D21 Mic/Line In Card

1.949.427.00/81

Modification of 1.949.427.00

Modification of 1.949.427.81

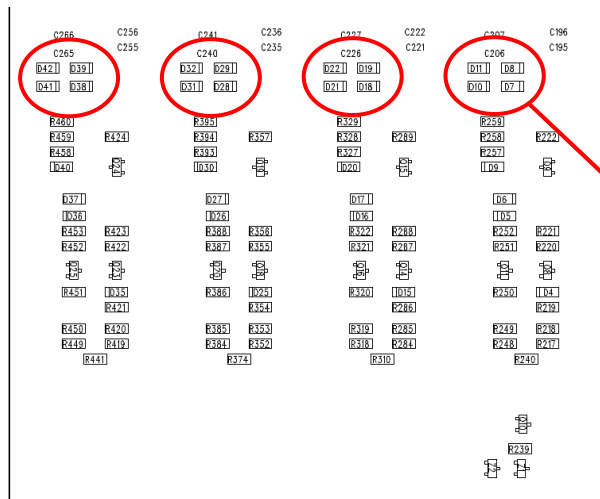
The input of The Mic/Line In Card may be damaged when phantom power is switched on and the input signal is short circuited. This may e.g. happen when using patch bays with connectors causing a temporary short circuit during the plugging of the connector (was reported from bantam connectors).

A first modification (Index 00 Rev "B" and Index 81) improved the problem, a later second modification (Index 00 Rev "C" and Index 81 Rev "A") fixes a resulting problem with clicks at a particular gain position.

There are 2 diodes to be replaced for each of the 4 inputs (see D10, D11 for CH1 at left).

Upgrade with 8 diodes / board
 Rev. "B" with new diodes SS14
 Rev. "C" with new diodes S1B (Order No 50.60.8003)

Please note : The new diodes are larger and need to be soldered to the 4448 diode next to it.

1.949.427.81 Bottom/Front

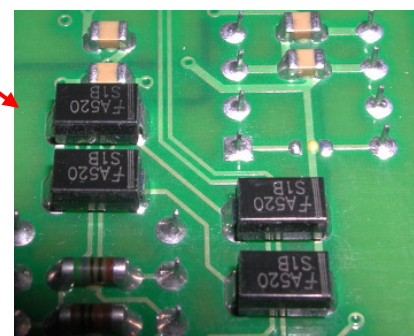
All 4 diodes of an input are replaced (see D7/10 and D8/11 for CH1 at left)

Upgrade with 16 diodes S1B (Order No 50.60.8003) / board

Fig.2 Keyboard drawer

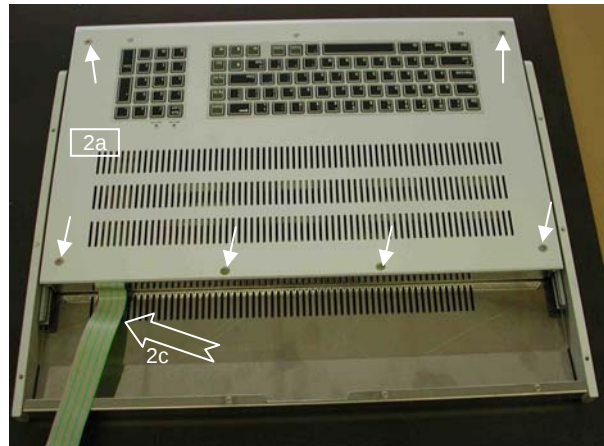
Please note : there were a few drawer bottom frames with mirrored cutouts, so that the ribbon cable is moving over the edges (fig 2c). It is recommended to attach an isolation sheet on the bottom to protect the cable. Suitable sheets are available from Studer product support on request.

Core Backplane 1.950.650.00

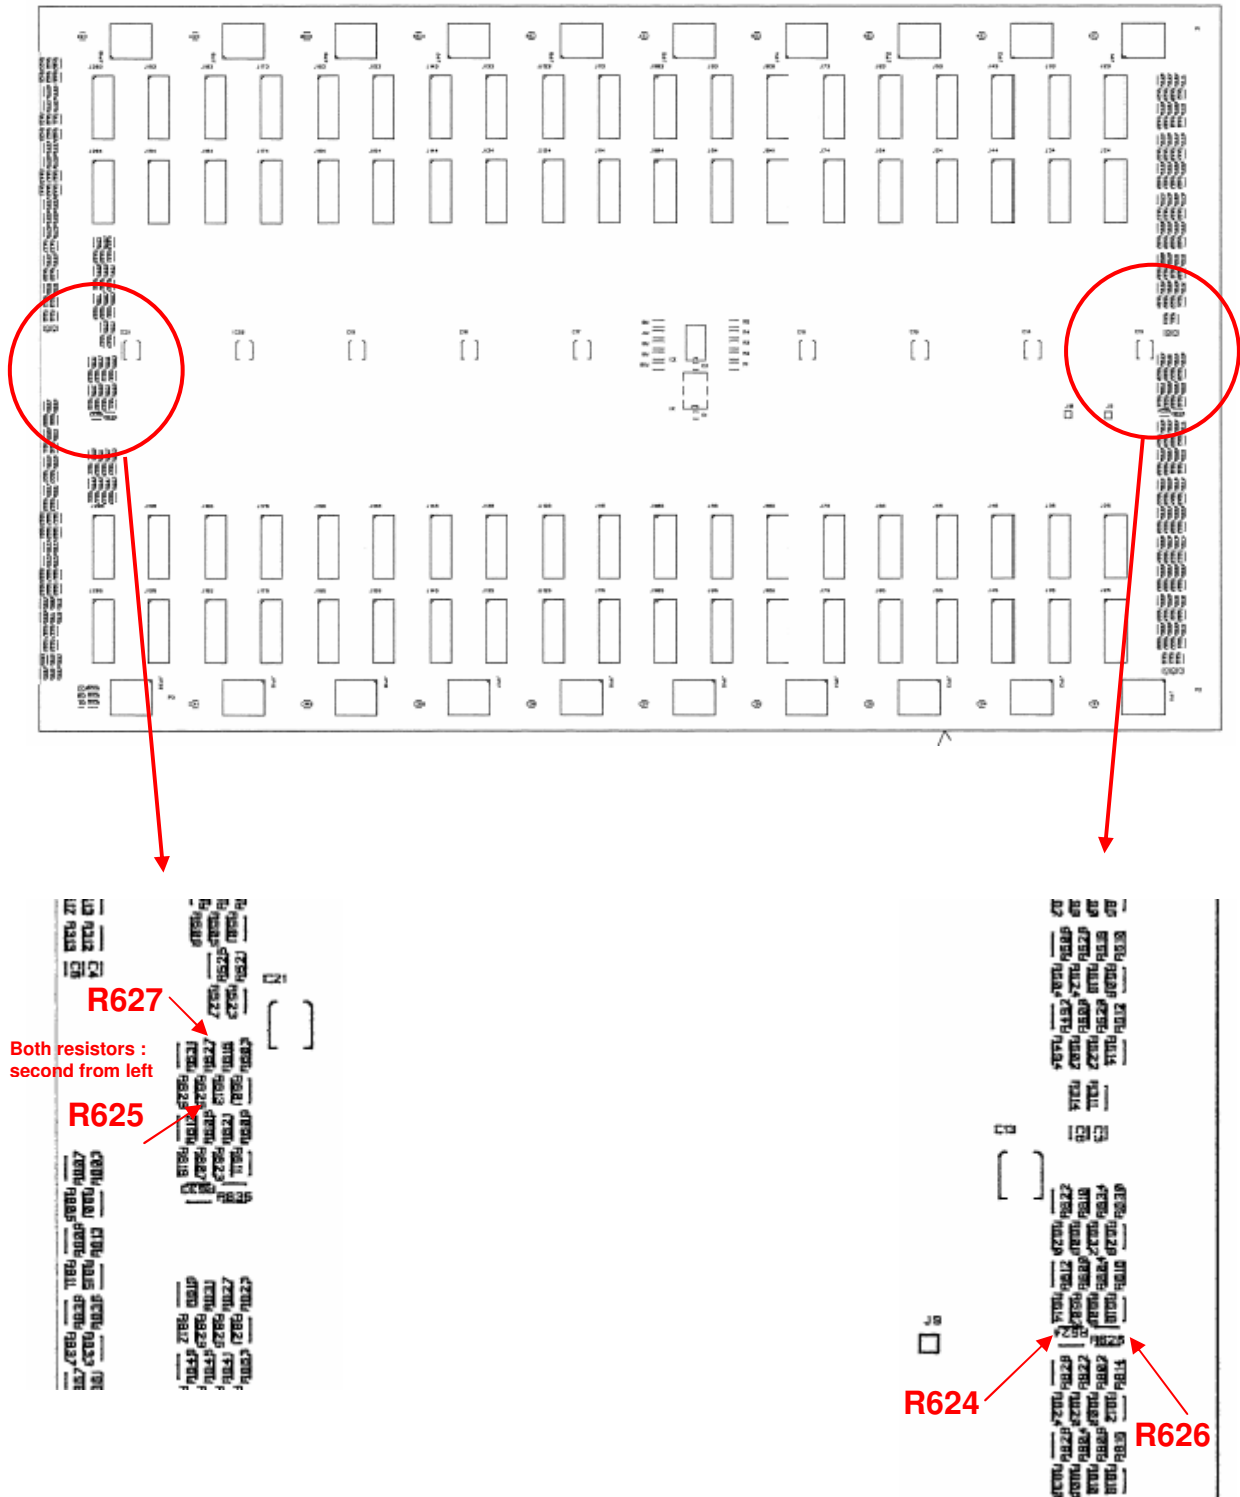
- When using more than 1..2 PE21 cards in a DSP Core, the backplane needs to be modified to 1.950.650.00 Rev A (shipped since Jun 2003) :
R 624 and R 625 change from 330R to 220R
R 626 and R 627 (470R) are removed
- A revision "B" modification (Sept 2004) improves reliability in fully equipped DSP cores by reducing pulldown resistors. Backplane and DSP Rack 1.950.692.81 are arked with a revision "B" label.
